Noise Feasibility Study

Proposed Mixed Use Development

16114 Airport Road

Caledon, Ontario

Figure 3: Proposed Concept Plan Showing Ventilation Requirements

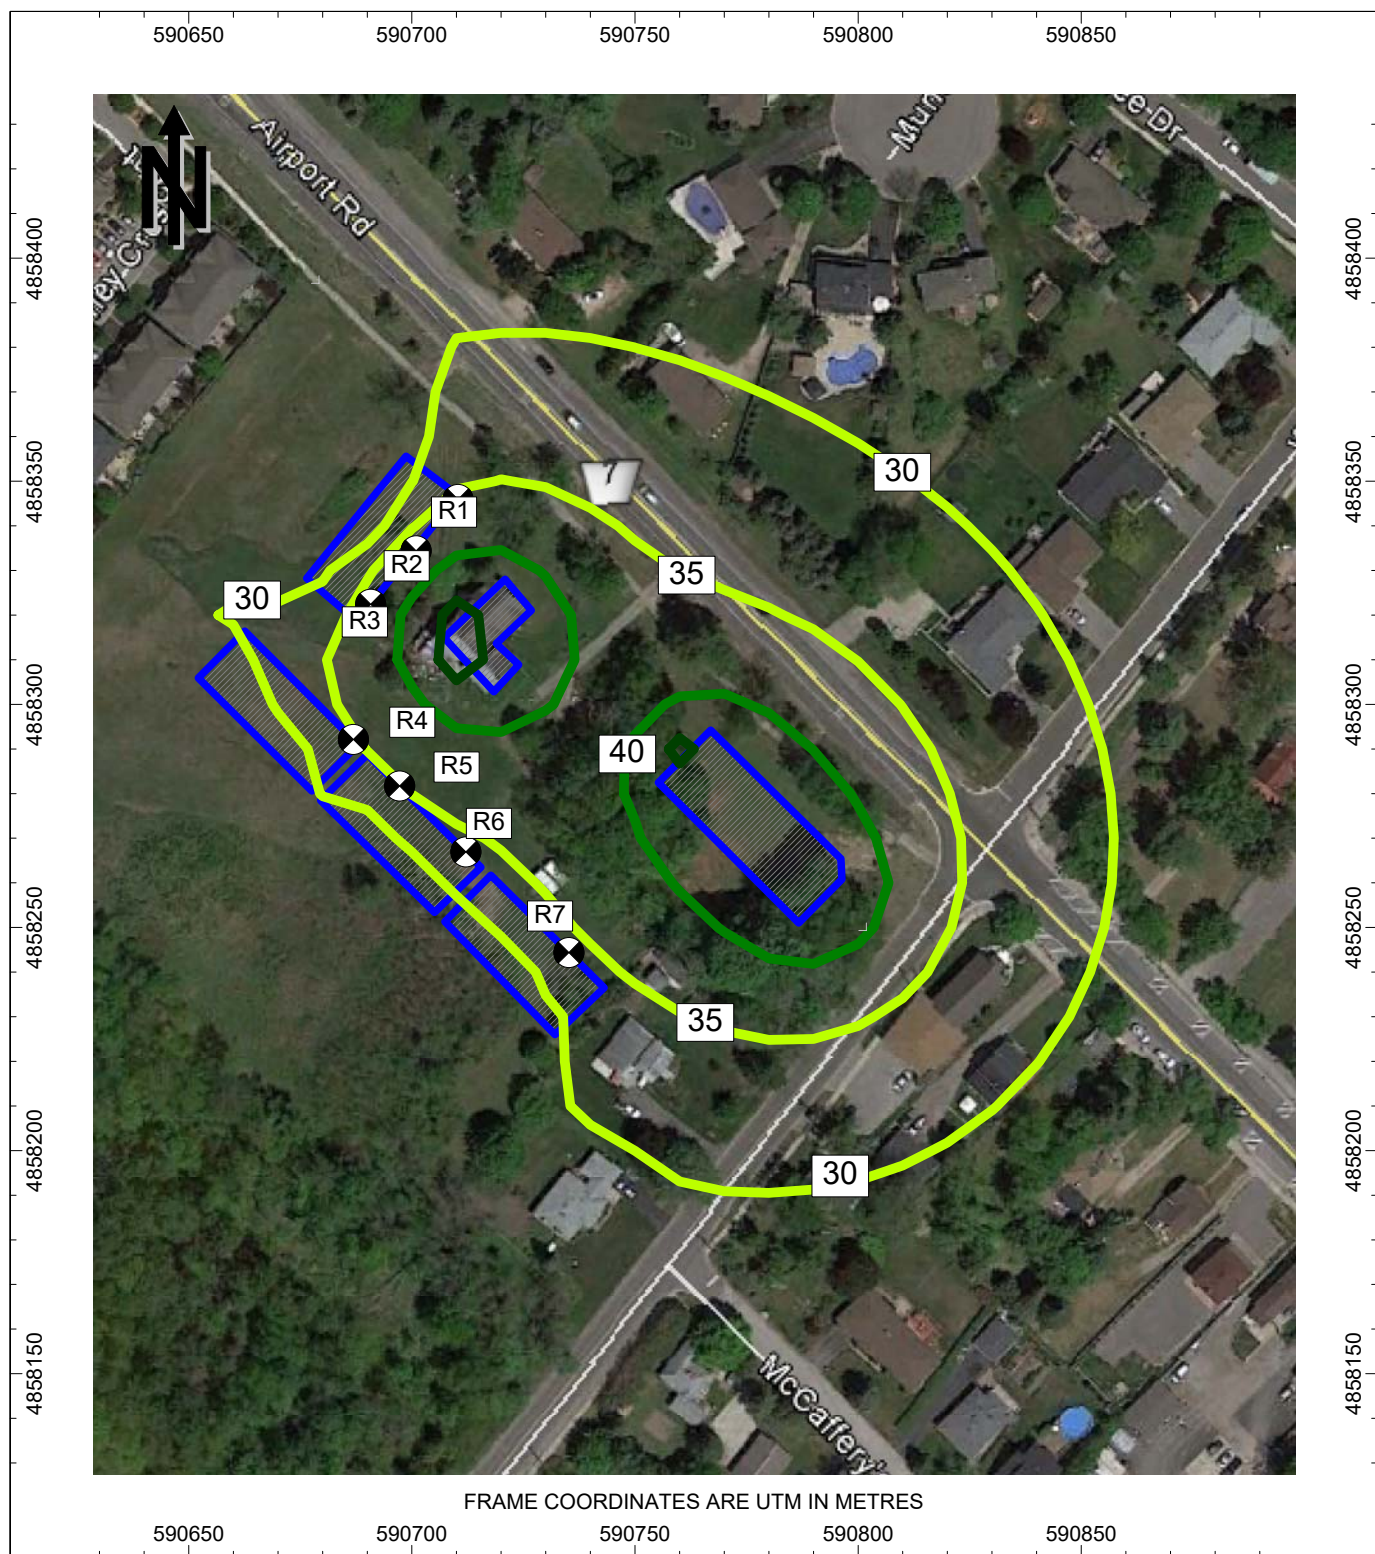
<p>c. The revised report must include cross sections of the noise wall and berms attenuating noise from Airport Road (showing the land dedication, buffer block, berm, and wall).</p> <p>d. Please show the proposed noise wall location on the plans. Please note that the proposed noise barrier will need to be on the private side, 0.3 meters inside the lot line.</p> <p>e. Please ensure that the Warning Clauses recommended in the study are consistent with the Region's guidelines. Once a table summarizing the unmitigated and mitigated resultant DBA sound levels is included, the warning clauses should be revised. Where the sound levels will exceed MOECC noise criteria by 5dBA, the wording stating that noise levels 'may' be of concern/interference must be replaced with 'will.'</p>			
<p>Toronto and Region Conservation Authority Contact: Anant Patel Tel: 416-661-6600 ext. 5618 October 25, 2017</p>

The location of the acoustic barriers is shown in Figure 3. For the remaining dwelling units, the sound levels will be 55 dBA or less, and further physical mitigation is not required. With a 1.8 m high acoustic barrier along the side and rear yard of dwelling units flanking onto Airport Road (prediction location [A] and [D]), the sound levels in the rear yards of the adjacent units further away from Airport Road will be less than 55 dBA. Further physical mitigation will not be required.
